On-Site Wastewater Technical Advisory Group

June 10, 2014
Kittitas County Courthouse
County Commissioners Chambers
Ellensburg, WA

Meeting Summary

SUMMARY OF TECHNICAL RGF DISCUSSIONS

Figure 3 (existing)

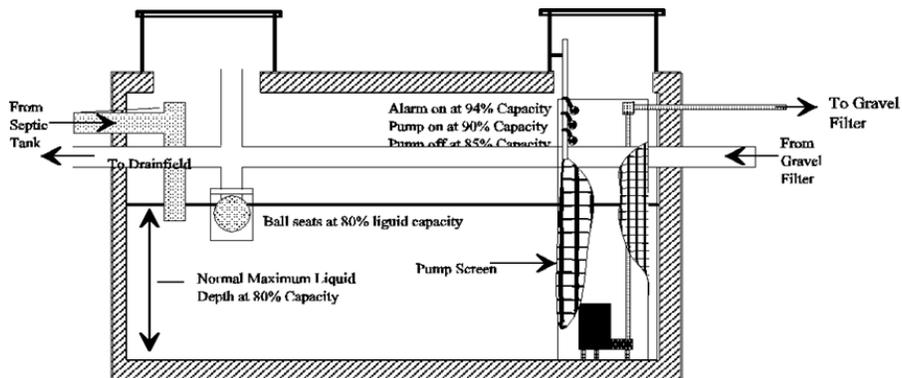
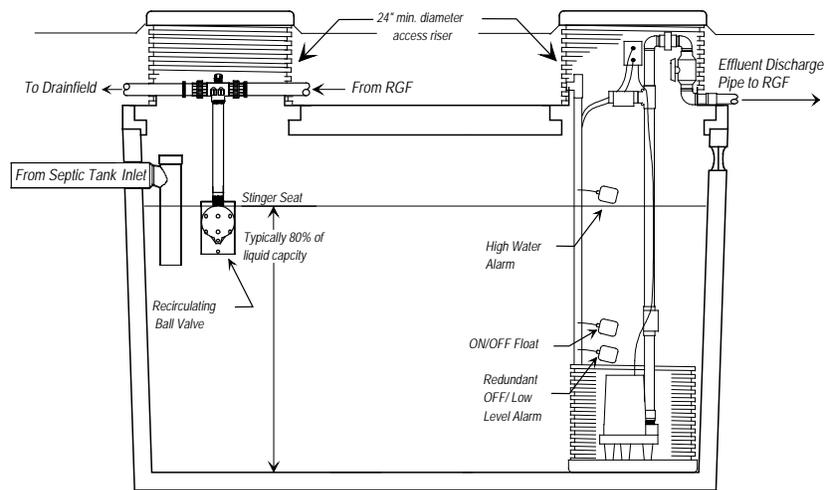
- 3) The group recommended updating Figure 3 with a new drawing (see draft below) showing the new OSI FRP recirculating ball valve with the feed pipe coming into the access riser instead of the sidewall of the tank so that the valve can be easily removed from above for maintenance. Recommendations were also made to remove the pump screen in Figure 3, and show floats settings consistent with the timed dosing requirements in the pressure distribution RS&G (no timer override float).

Figure 3 (proposed)
